Addendum 02

PROJECT: Fort Loramie Local Schools Athletic Complex Building & Associated Improvements
600 East Park Street
Fort Loramie, Ohio 45845

PROJECT #: 25041.00

This addendum consists of 4 page addendum, 14 pages of exhibits, 4 specification sections and 39 drawing sheets

1 / A1.1 DEMOLITION FLOOR PLAN
1/8" = 1'-0"

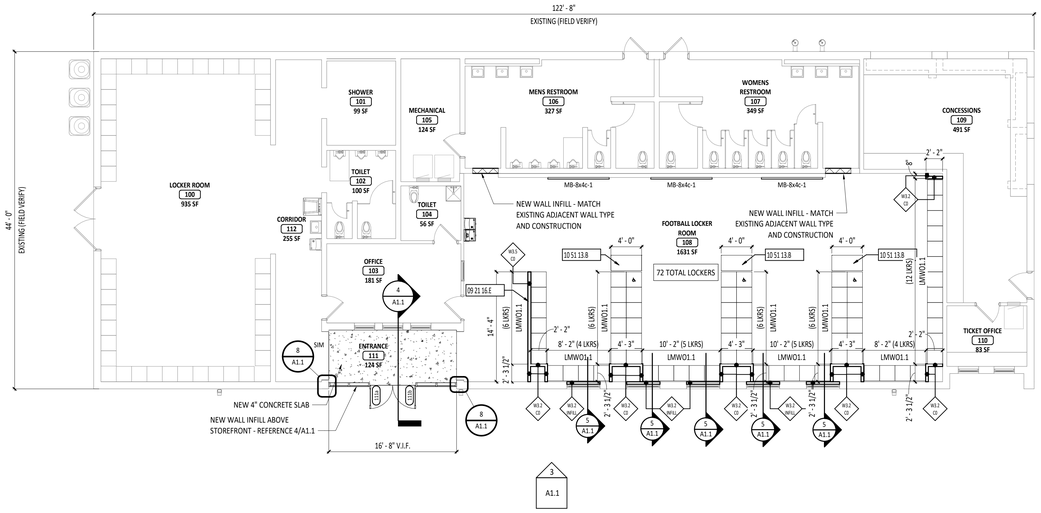
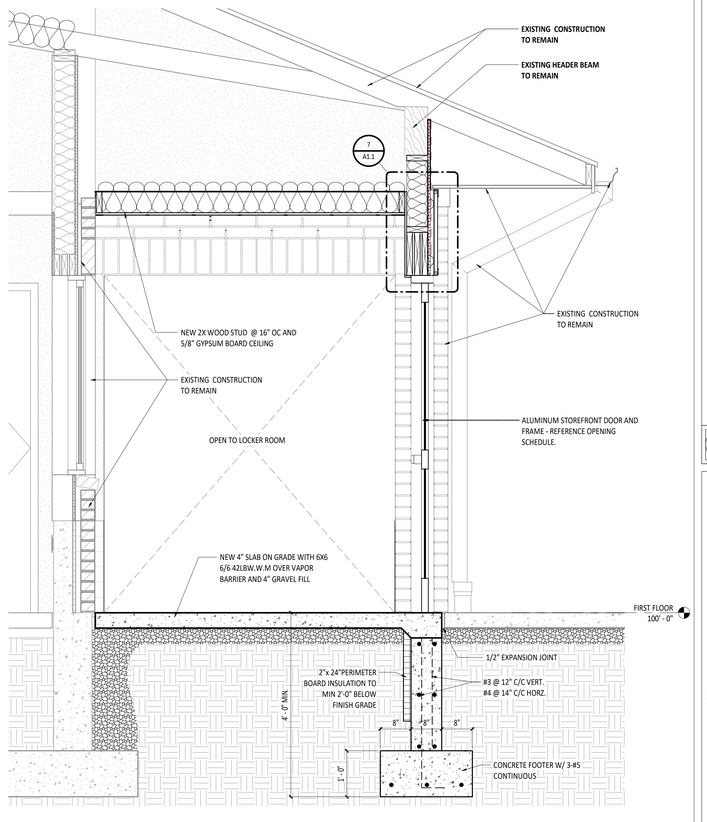
1.) A1.1 Demo Plan/ Floor Plan/ Details/ Door Schedule – Revised detail 5/A1.1, note to add LED strip light above lockers and revised note to window film. Revision made to Locker Schedule to read "welded lockers". Detail 3/A1.1 – revise window film note.
2.) A9.1 First Floor Equipment & Finishes Plan – Revised font for painted graphics. Revision made to Locker Schedule to read "welded lockers". Detail 7/9.1 – TVs added for reference.
3.) E1.2 Electrical Details, Panel and Luminaire Schedules – Revisions to Panel and Luminaire Schedules.
4.) E4.1 Electrical Plan – Revisions to the Lighting Plan.

1 L1.1 SITE LAYOUT AND MATERIALS PLAN
1/16" = 1' - 0"

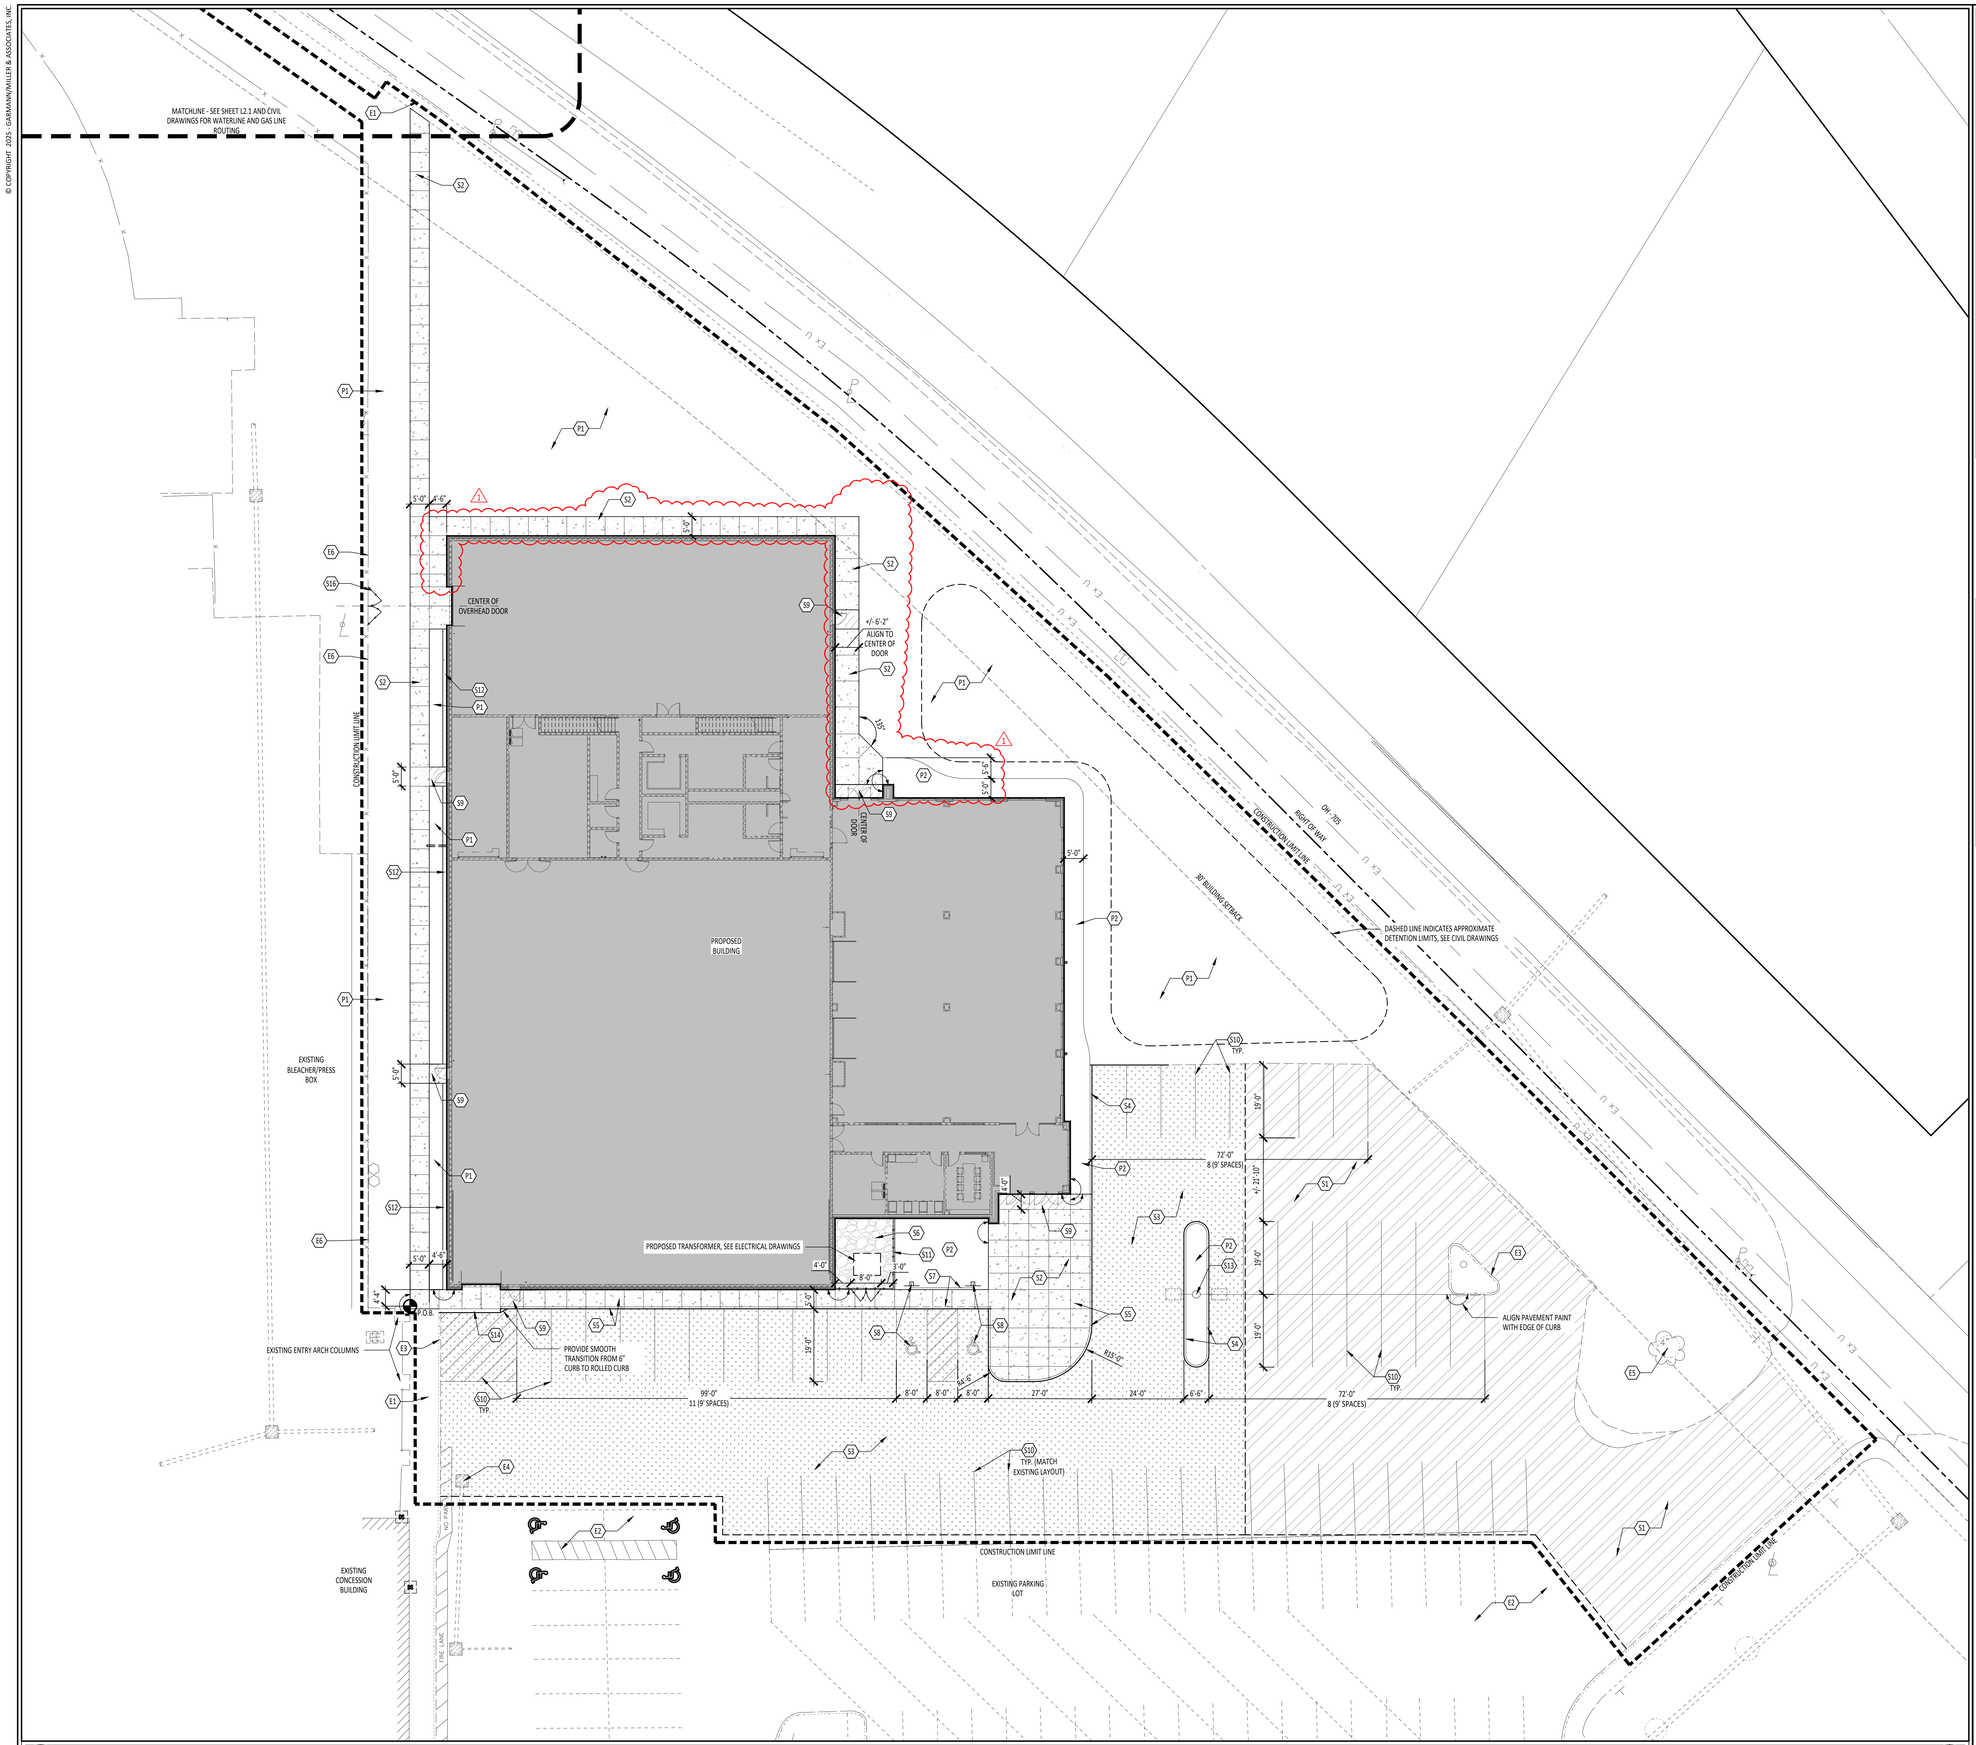
4.) L1.1 – Revised walk layout along North and Northeast side of proposed building
    a. New walk to wrap around the north side.
    b. Remove concrete stairs and handrails from the scope.

3 L3.1 PLANTING PLAN
1" = 10'-0"

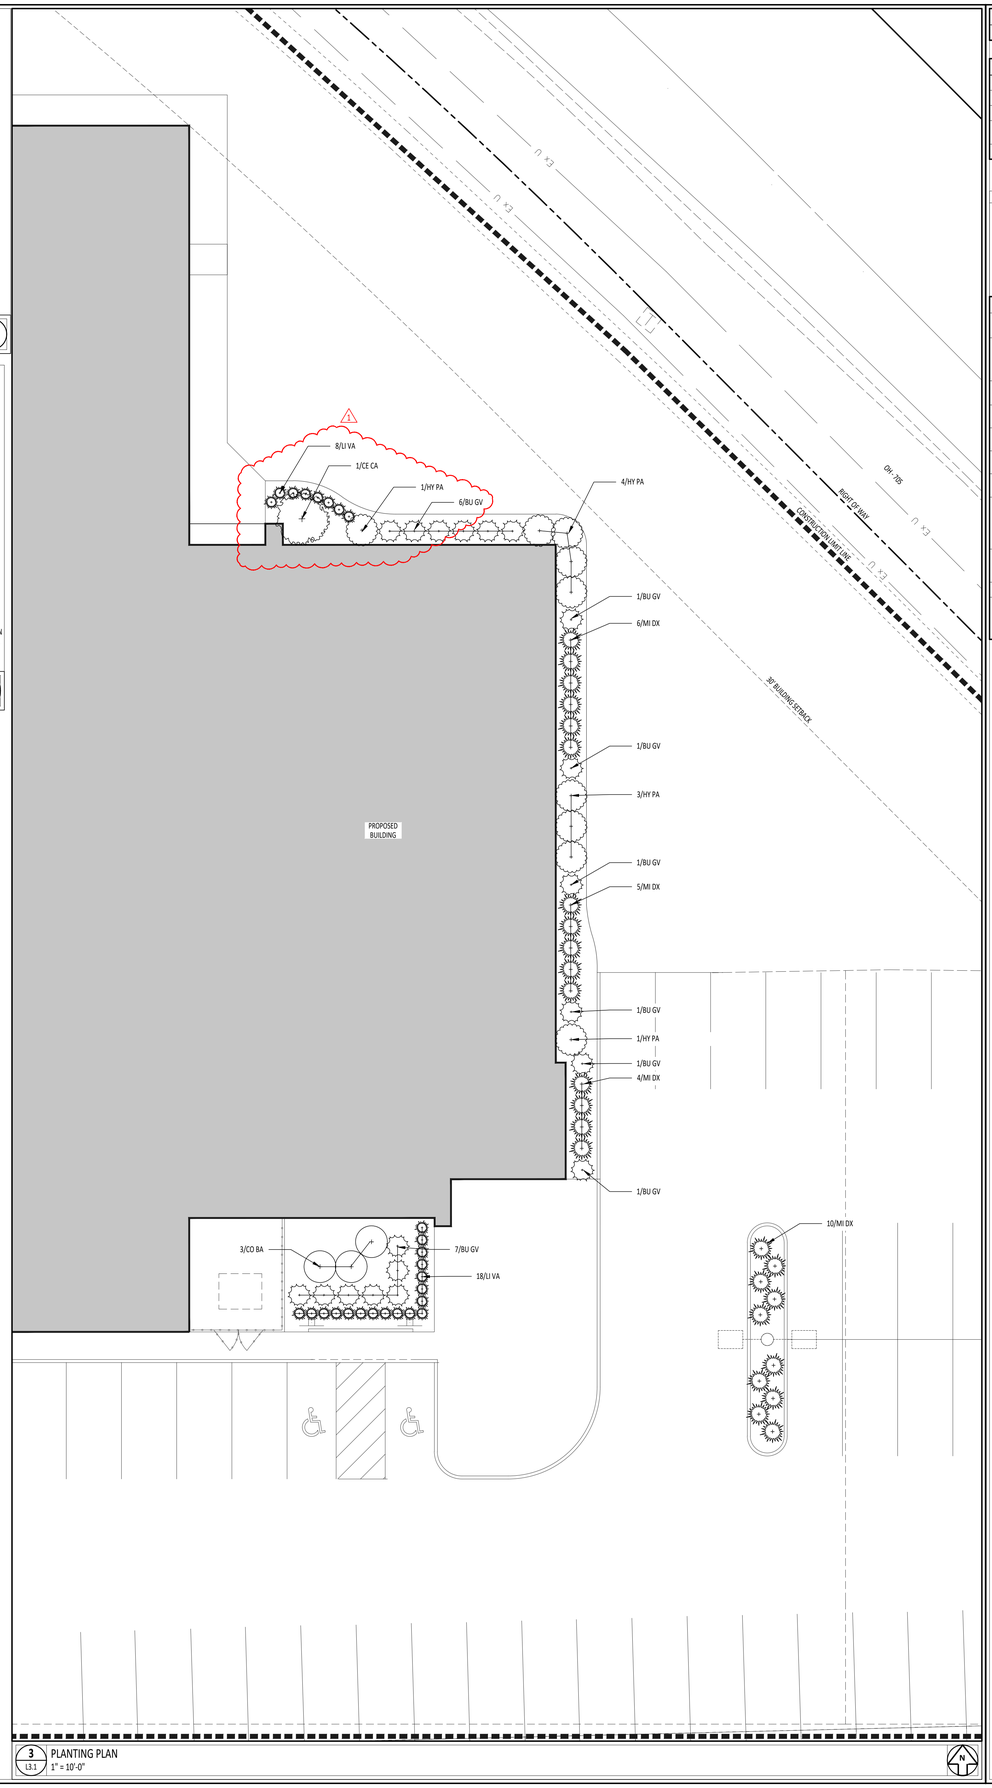
5.) L2.1 – Removed concrete stair detail
6.) L3.1 – Revised plant bed layout
    a. Reduced (2) Variegated Lily Turf
    b. Added (1) Green Velvet Boxwood

TYPICAL DETAILS

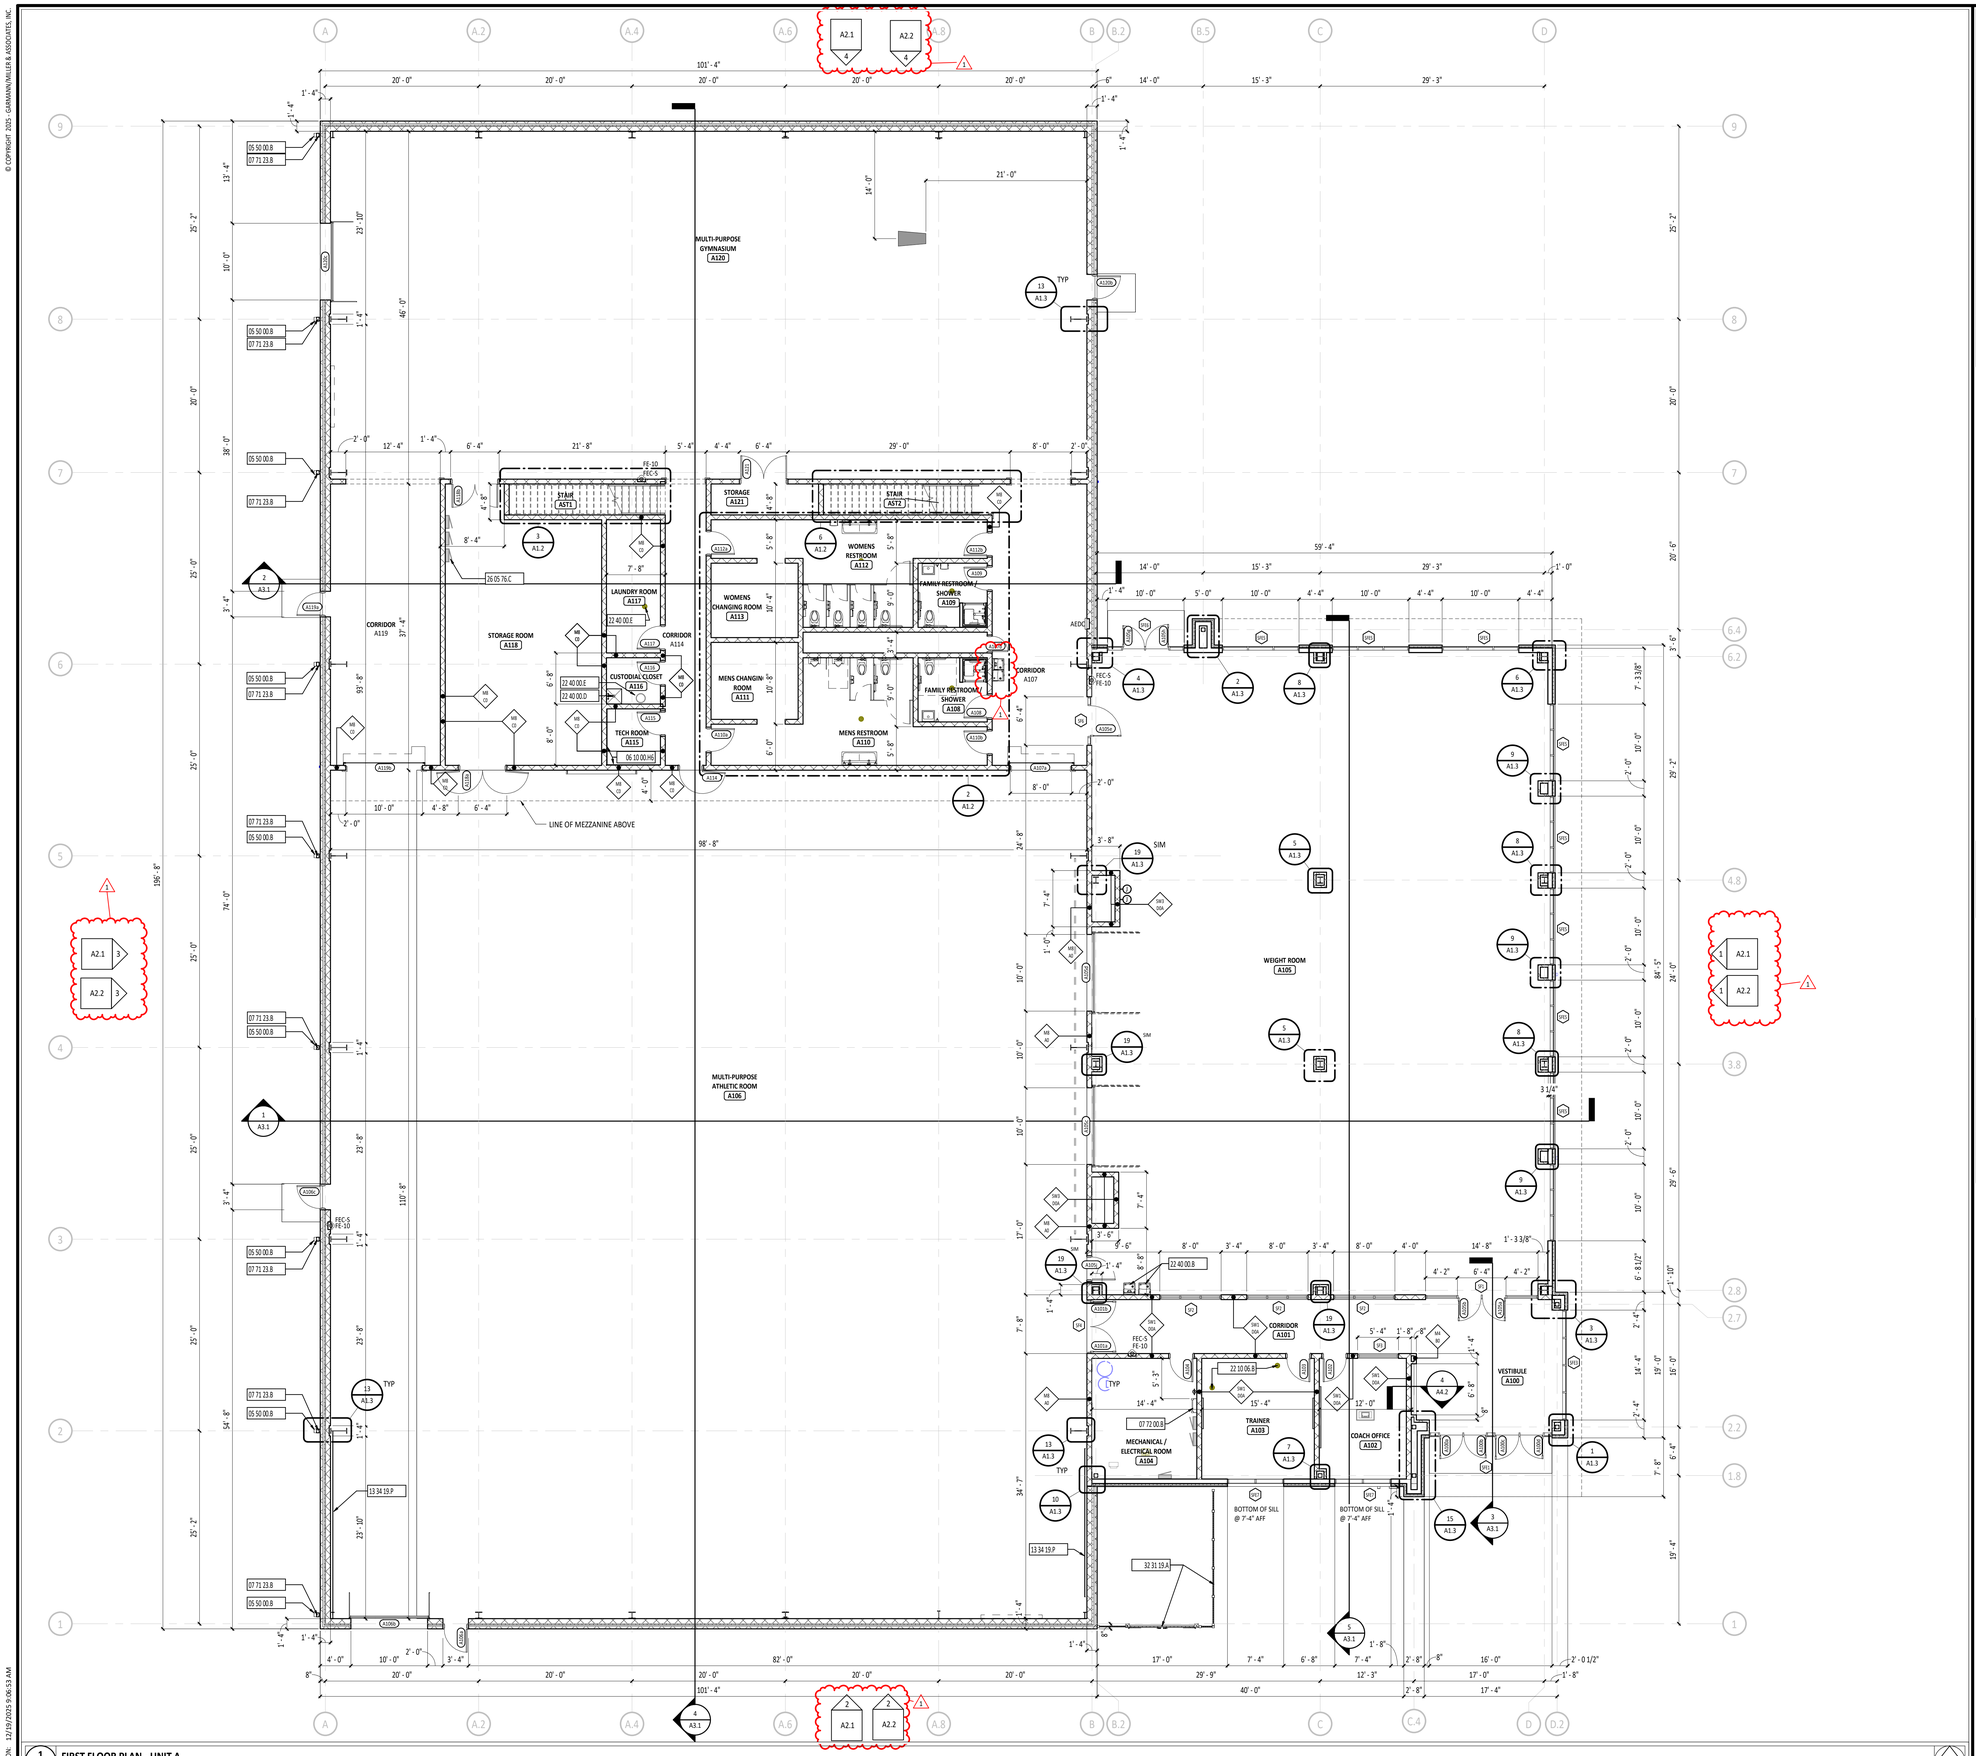
7.) A0.3 Typical Details – Added mockup wall detail
8.) A1.1 First Floor Plan – Remove 4" CMU partial height walls and adjust overlapping elevation tags

1 A1.1 **FIRST FLOOR PLAN - UNIT A**
1/8" = 1'-0"

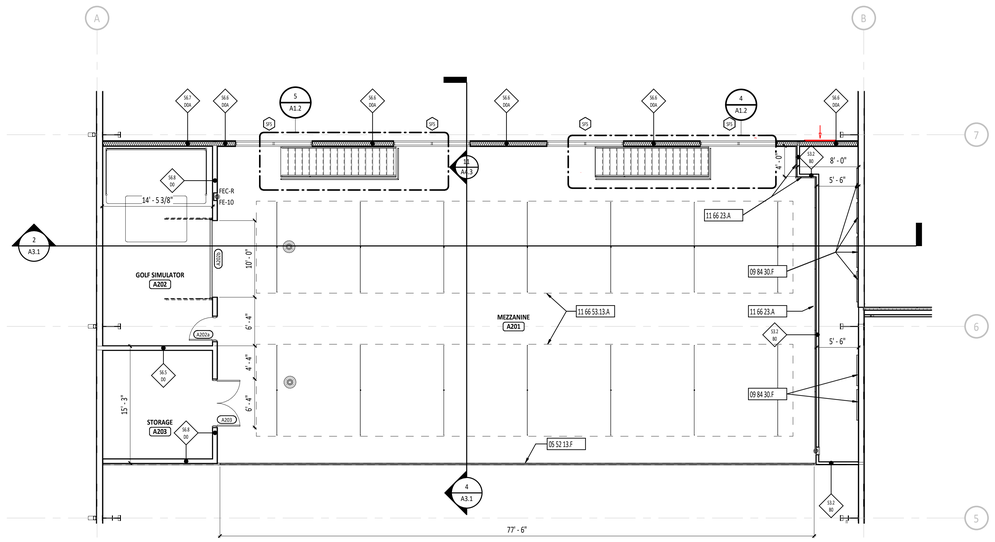
23. Sheet A1.1 references and elevation on sheet A2.2. Does not exist.
    a. **Response: Addressed in Addendum 2. Sheet A2.2 has been added to set and overlapping tags have been adjusted**
